Access Compliance Report Public Rights-of-Way (Curb Ramps)

Main Street: GILBERT_ST Cross Street: STONYBROOK_DR Location: NE

ADA ID: RPAT220202163836 Ramp Type: Type 4 - Parallel Initial Pass/Fail: Pass Overall Compliance: No Severity Score: 5

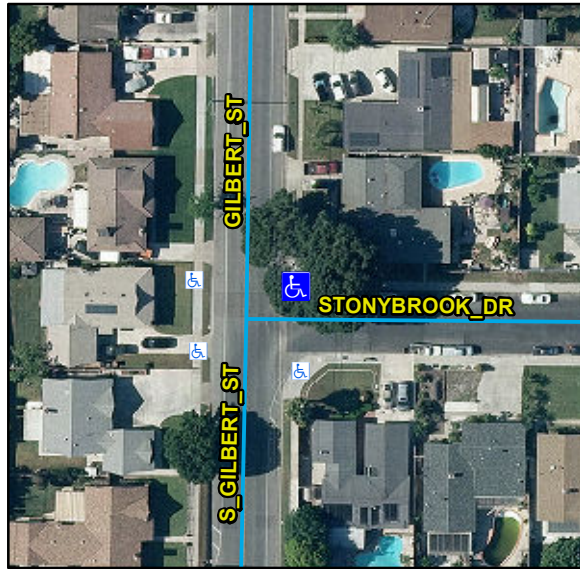
Crossing 1 Slope (%)	3.8		Crossing 2 Slope (%)	N/A
	Crossing 1 Cross Slope (%)	2		Crossing 2 Cross Slope (%)	N/A
Yes	Gutter Ponding	No	Yes	Curb Slope	7.2
Yes	Gutter Lip Height (in)	0		Road Run Slope (%)	N/A
No	Gutter Run Slope (%)	6.1		Road Cross Slope (%)	N/A
Yes	Gutter Cross Slope (%)	0.2	Yes	Perpendicular Joint Present	Yes
Yes	Overall Surface Condition	Acceptable			
	Cross Gutter Present?	Yes		Spandrel Present?	Yes
	Replace Cross Gutter?	No		Replace Spandrel?	No

Remove & Replace Gutter.

R304.5.4, STD 1115
